COMMENTS AND RESPONSES | VOLUME 1: CHAPTERS 1-5

California Pacific Medical Center (CPMC) Long Range Development Plan

PLANNING DEPARTMENT CASE NO. 2005.0555E

To: Members of the Planning Commission and Interested Parties
From: Bill Wycko, Environmental Review Officer
Re: **Attached Comments and Responses on Draft Environmental Impact Report
Case No. 2005.0555E: California Pacific Medical Center (CPMC) Long Range
Development Plan**

C&R Figure 3.3-1

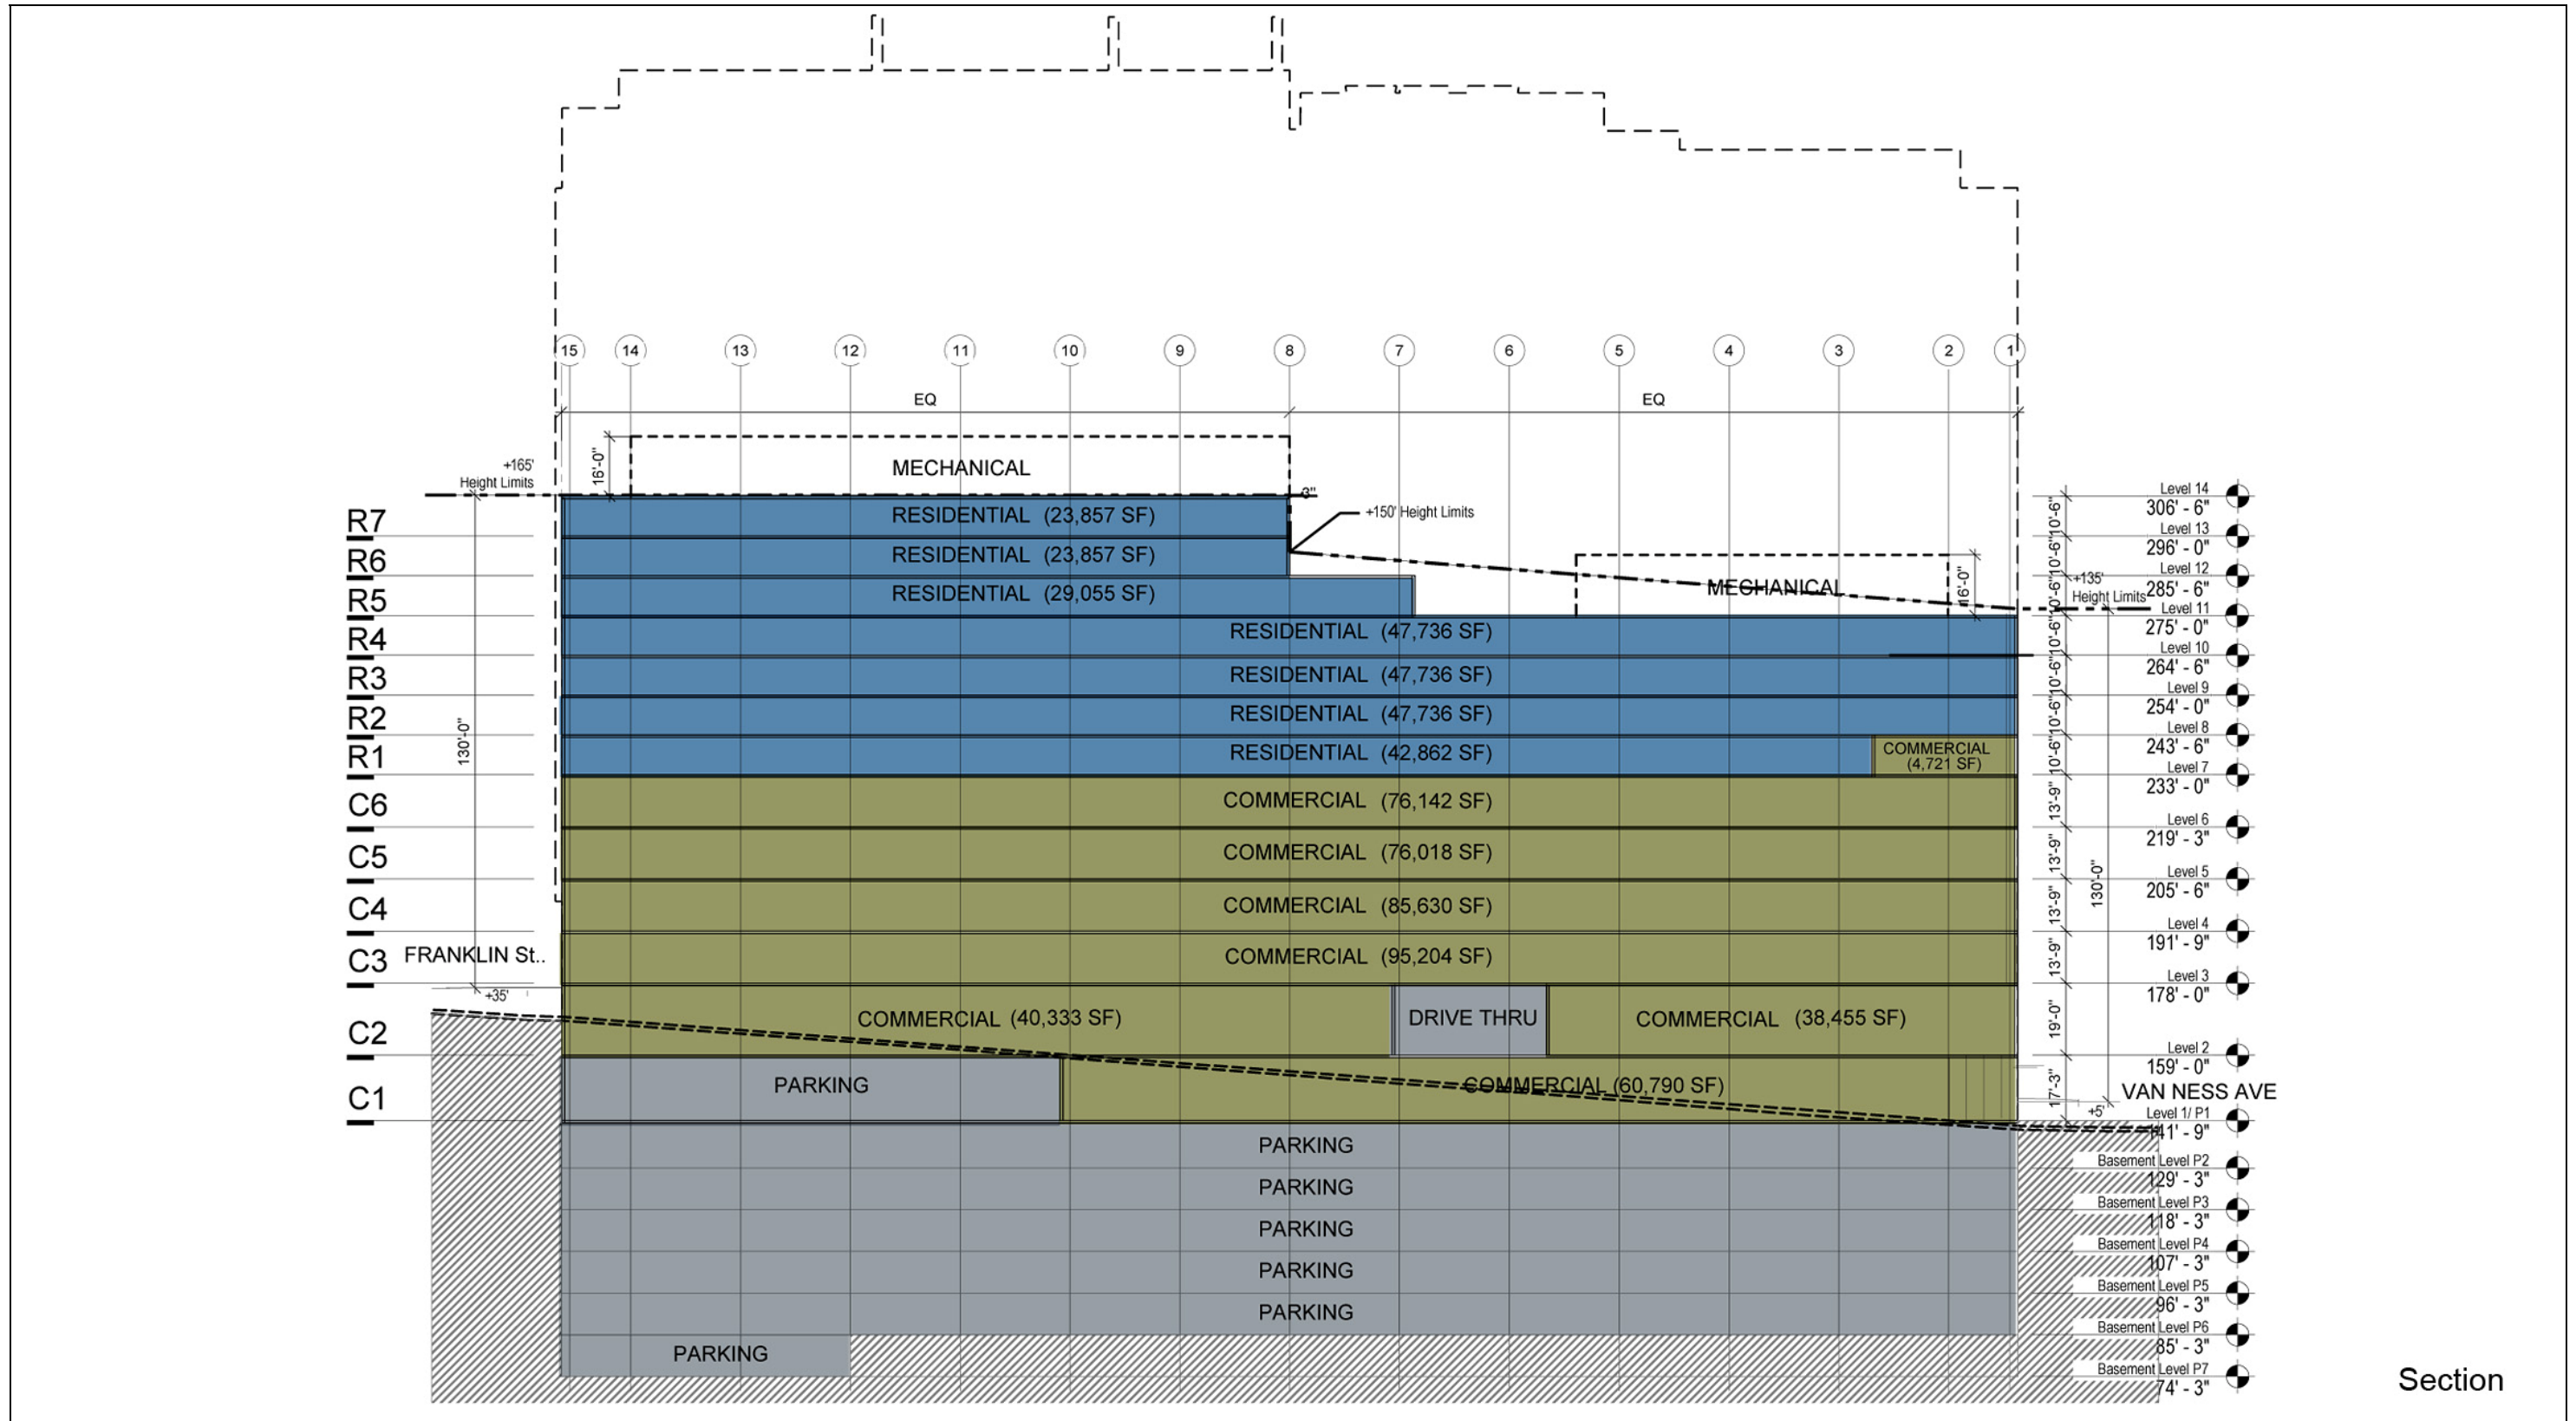
As depicted in C&R Figure 3.3-1 on C&R 3.3-105 for the proposed Cathedral Hill Hospital, a total of approximately 477,293 non-residential gsf and approximately 262,839 residential gsf would be constructed. To determine the residential sq. ft. required to meet the 3:1 ratio, the total gsf must be converted to occupied sq. ft. As stated above, approximately 197,129 sq. ft. of occupied residential area would be required to meet the 3:1 ratio. Using residential units of approximately 1,000 occupied sq. ft., there would be about 197 units on the proposed Cathedral Hill Hospital site.

C&R Figure 3.3-3

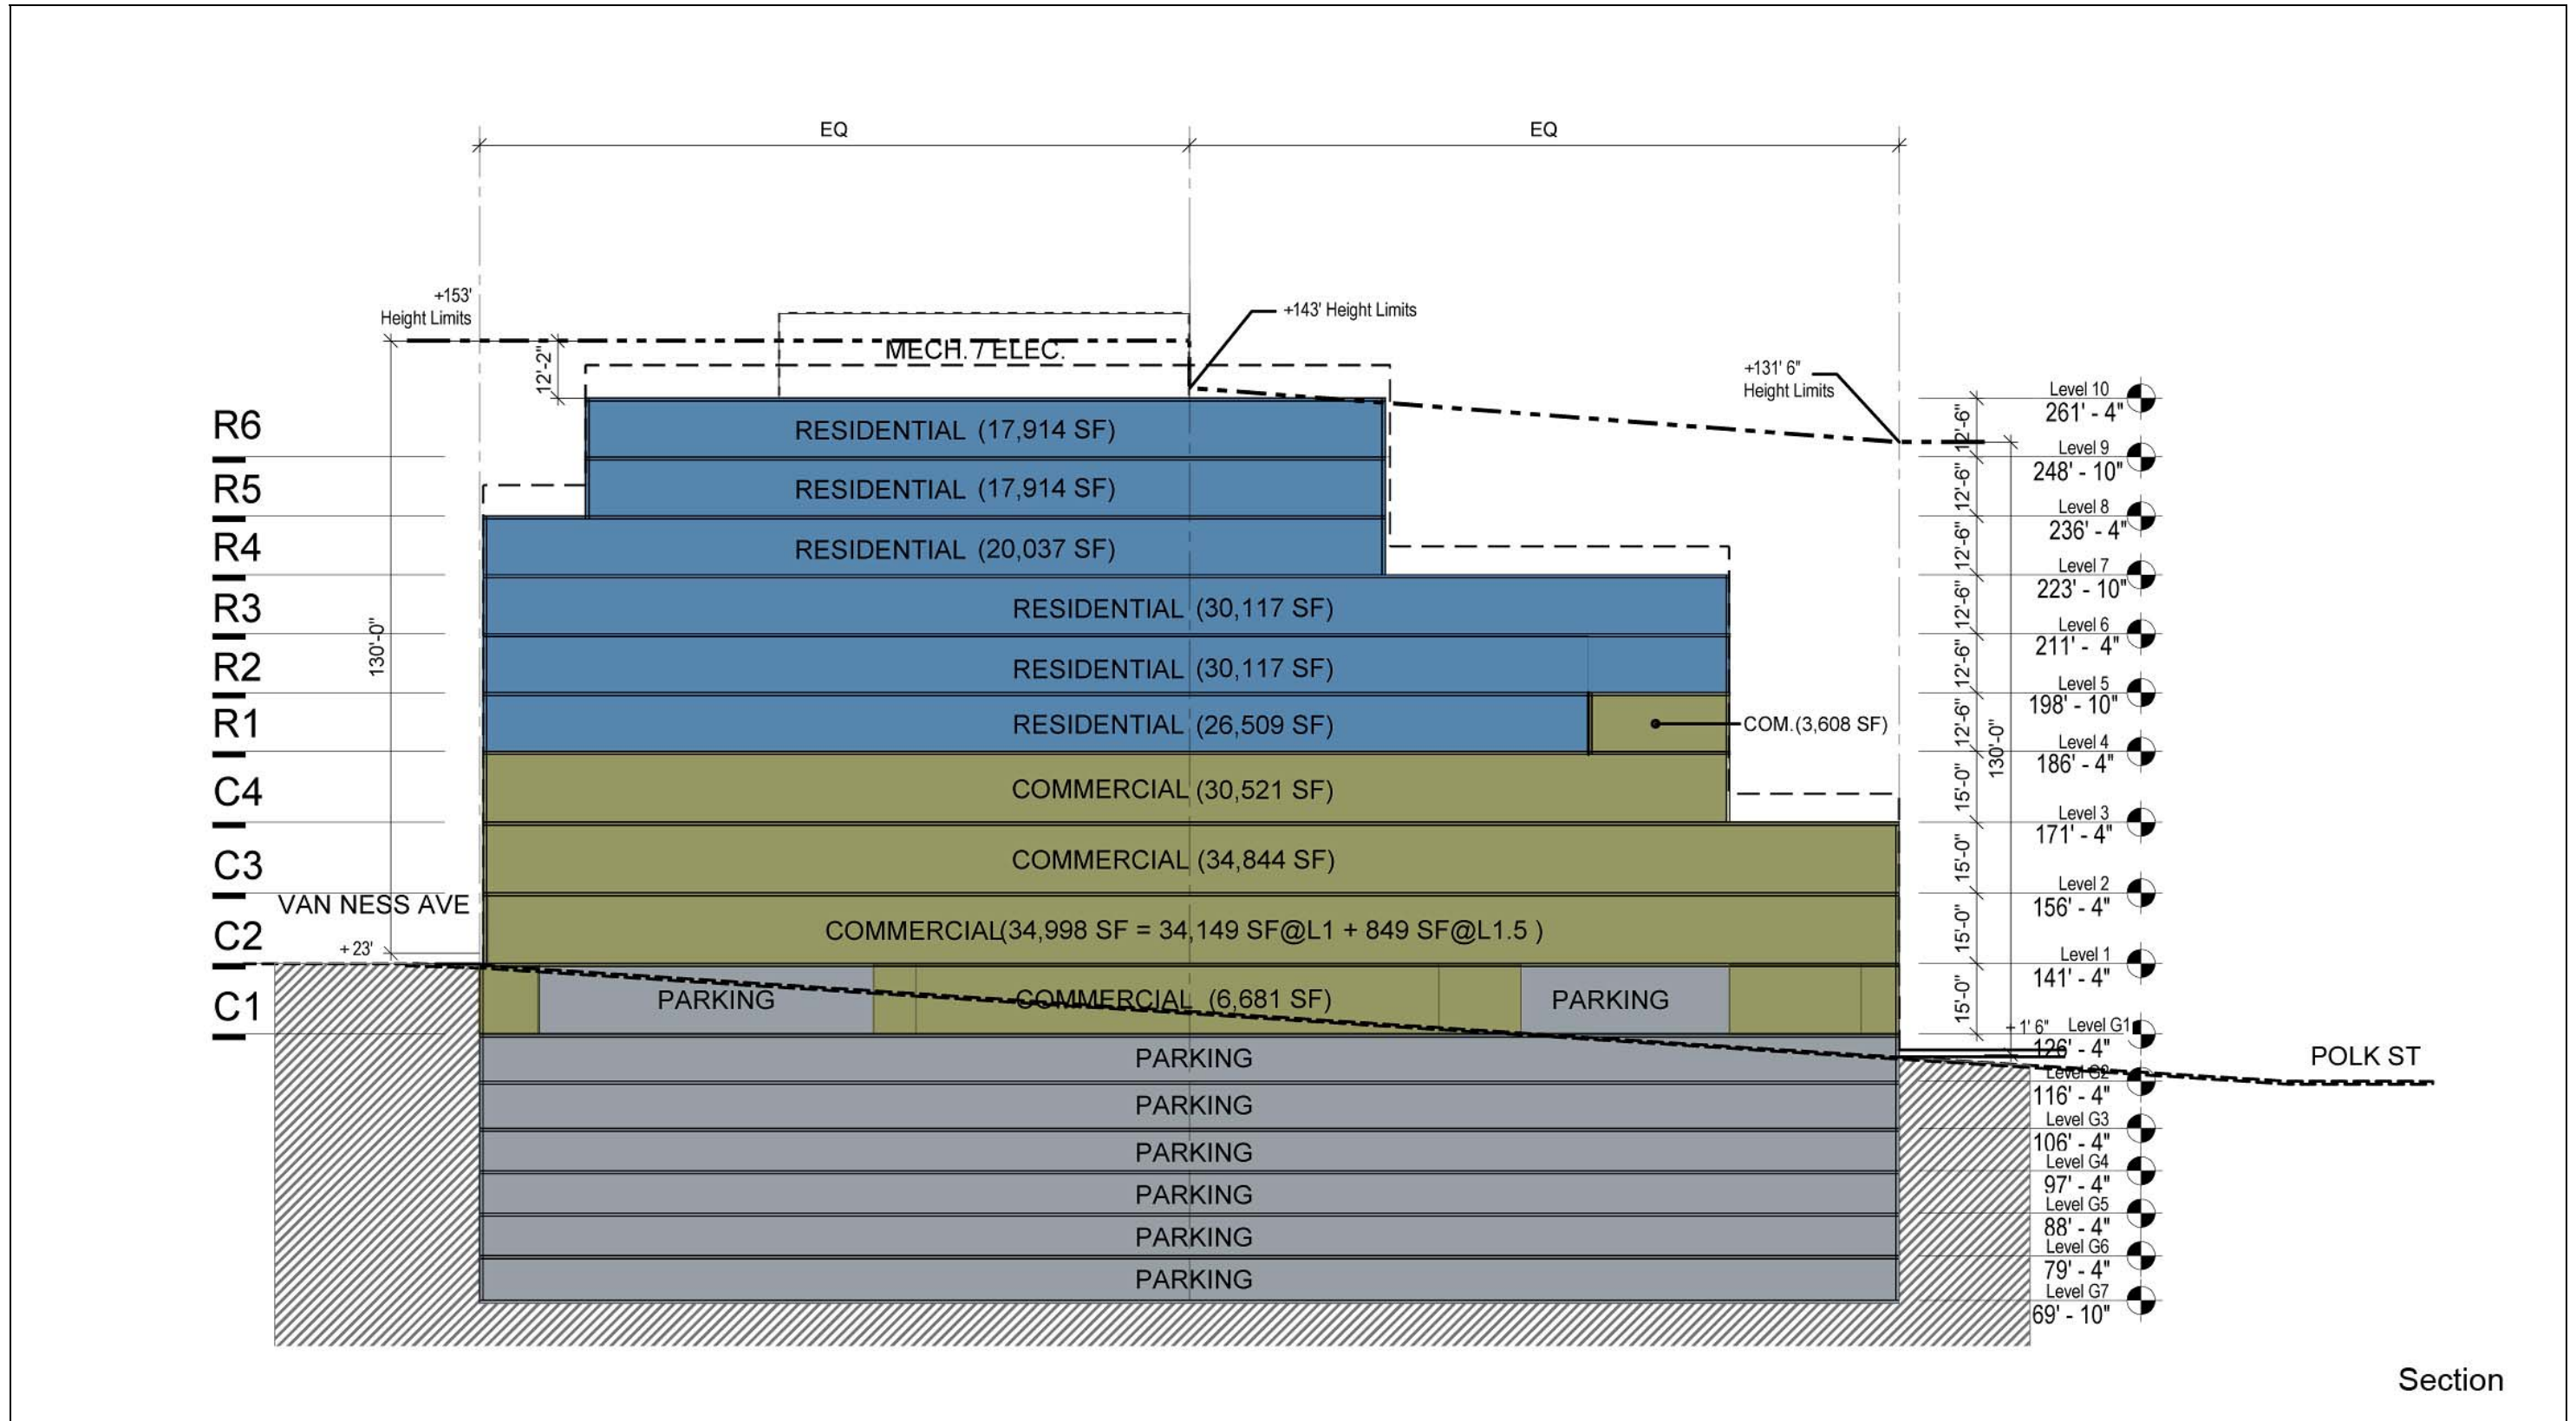
As shown in C&R Figure 3.3-3, "3D Massing Diagram" for the proposed Cathedral Hill MOB, a total of approximately 110,652 non-residential gsf, and approximately 142,608 residential gsf could be constructed. As stated above, approximately 106,956 sq. ft. of occupied residential area would be required

C&R Figure 3.3-7

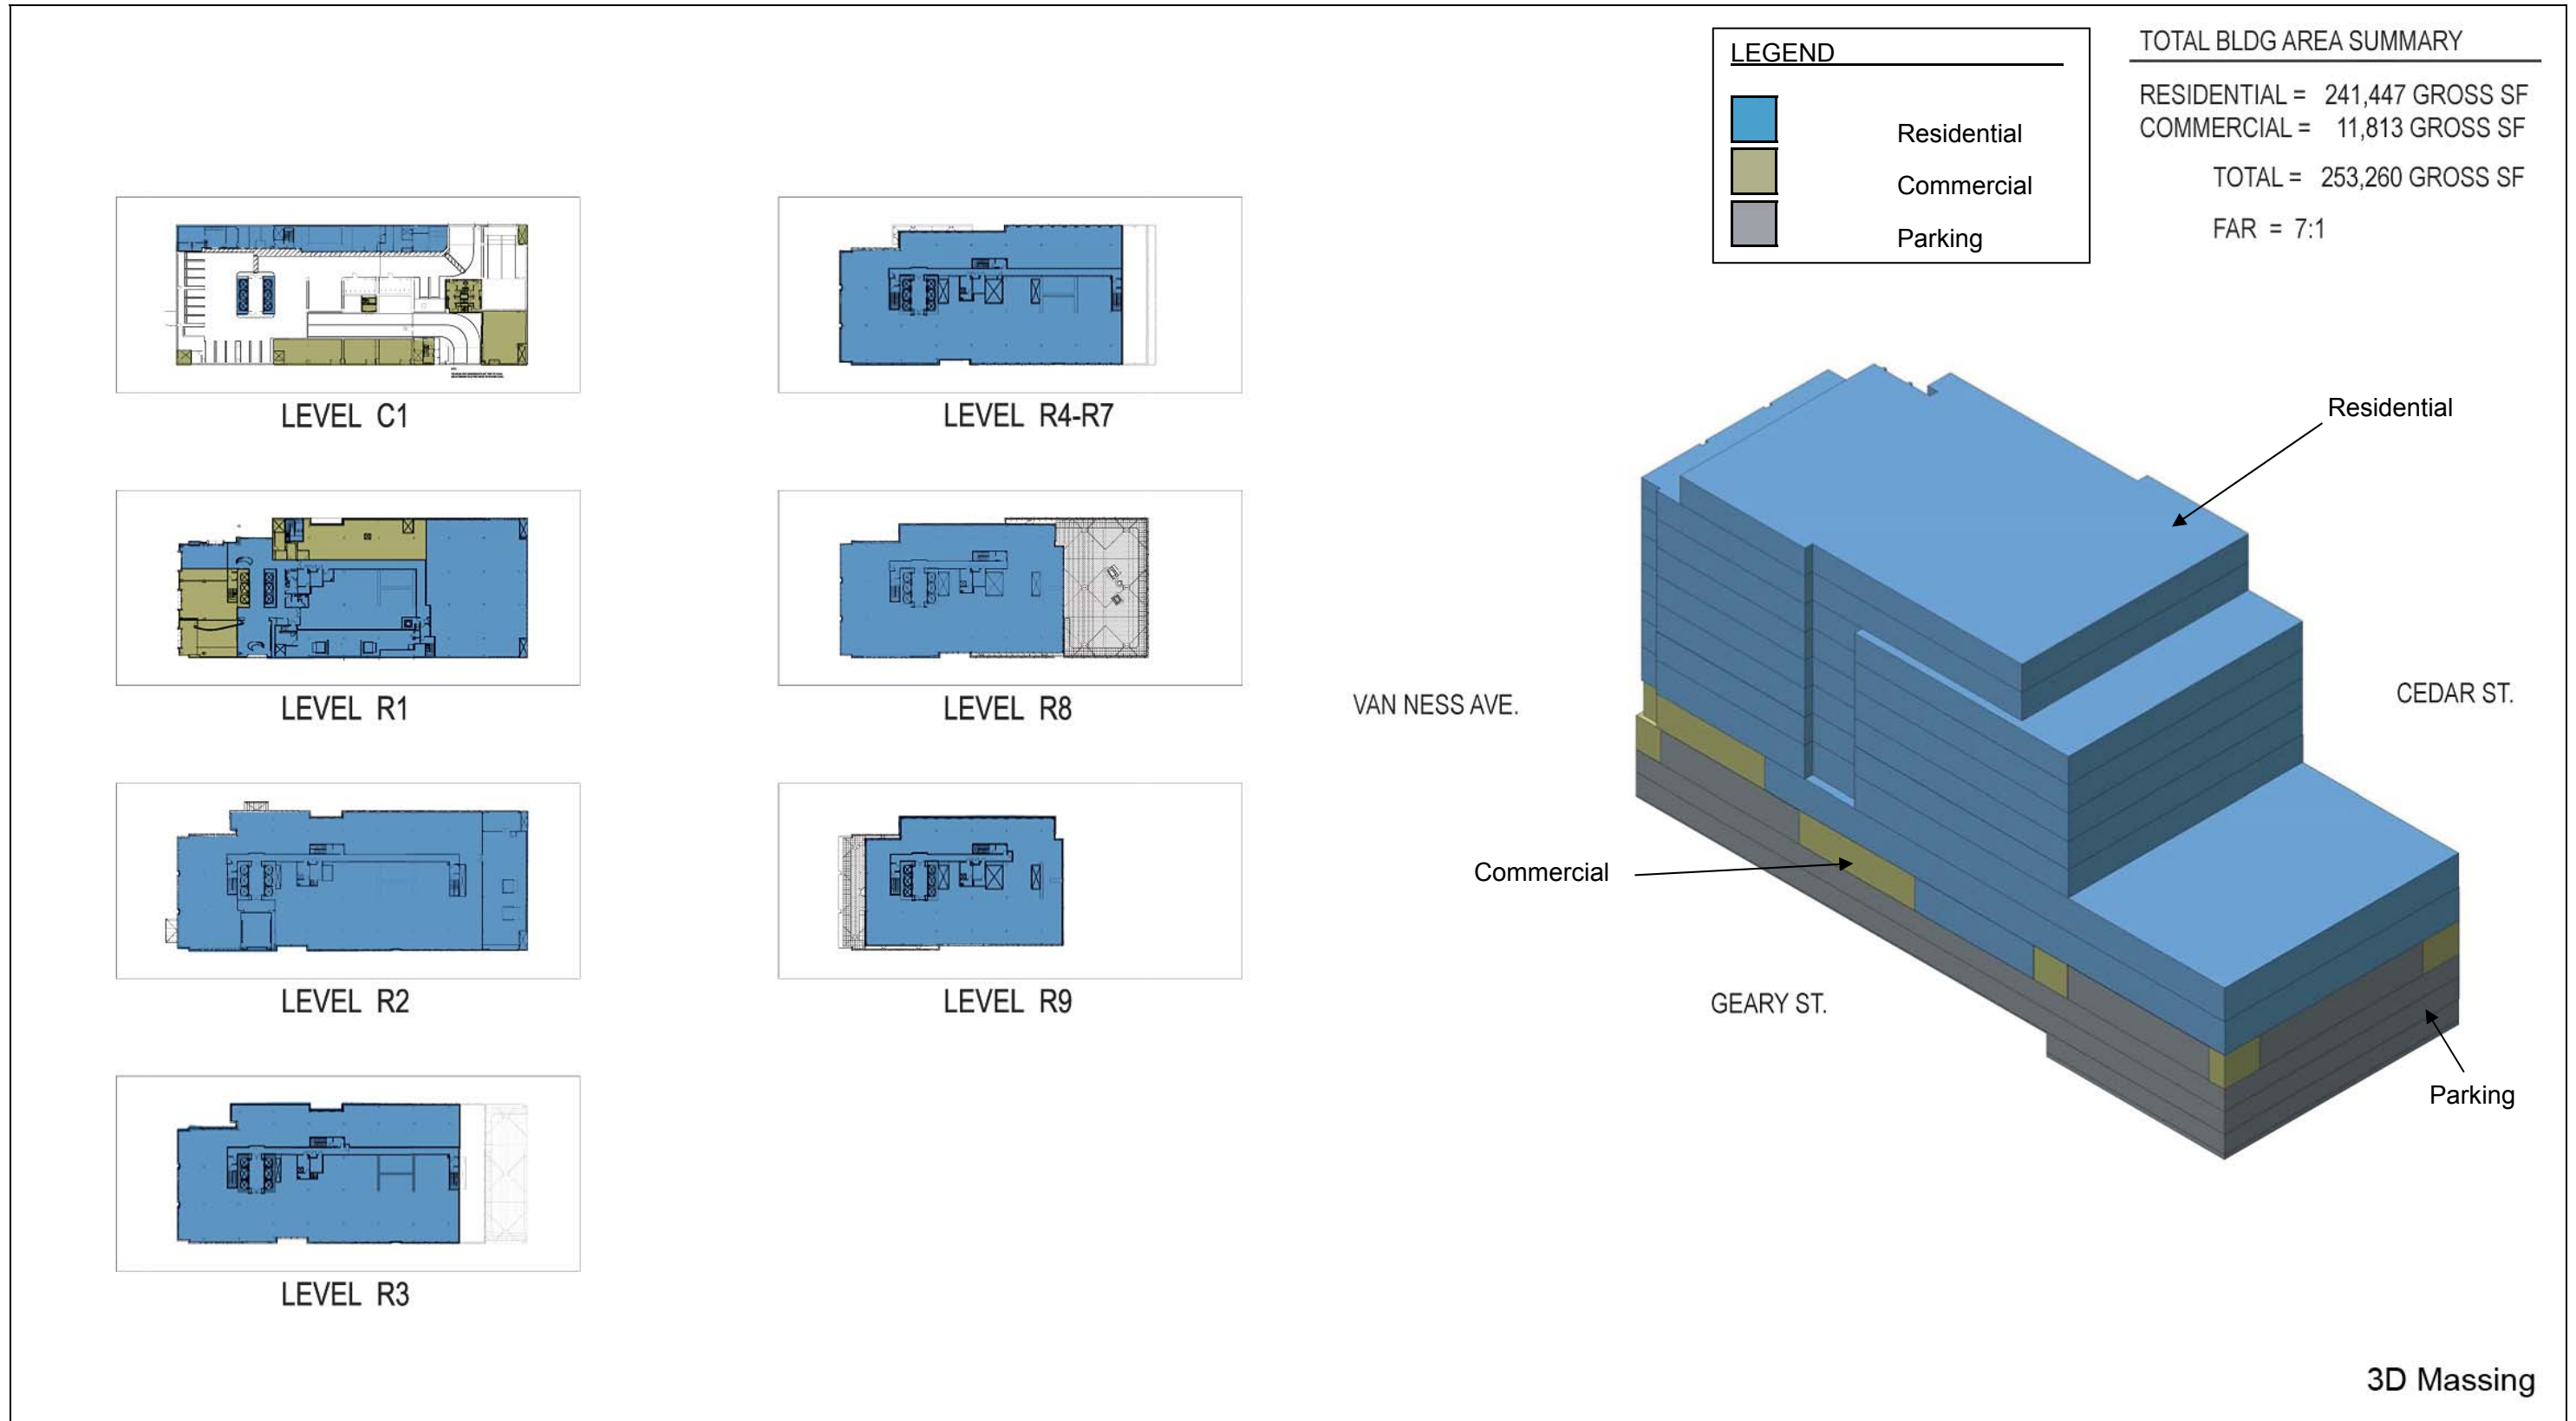
The proposed site of the Cathedral Hill MOB currently has a maximum 7:1 FAR. Based on the site area of 36,180 gsf, a 7:1 FAR would yield a maximum building area of 253,260 gsf or 189,945 occupied sq. ft. (75 percent conversion factor), as shown in C&R Figure 3.3-7 (page C&R 3.3-117). After subtracting the existing occupied area of approximately 60,205 sq. ft. from the seven buildings proposed to be demolished, the net new occupied area for the proposed Cathedral Hill MOB site would be approximately 129,740 sq. ft. Of this amount, approximately 97,305 sq. ft. would be required to be residential to meet the 3:1 ratio. To this amount, 9,651 occupied sq. ft. would be added for the existing residential that would be demolished, as well as the 74,129 sq. ft. of residential occupied area that would be required from the proposed Cathedral Hill Hospital site, for a total of 181,086 occupied sq. ft. of residential. The total gsf of residential area for the MOB site would be 241,447 (see C&R Figure 3.3-7, C&R 3.3-117) assuming a conversion factor of 75 percent.
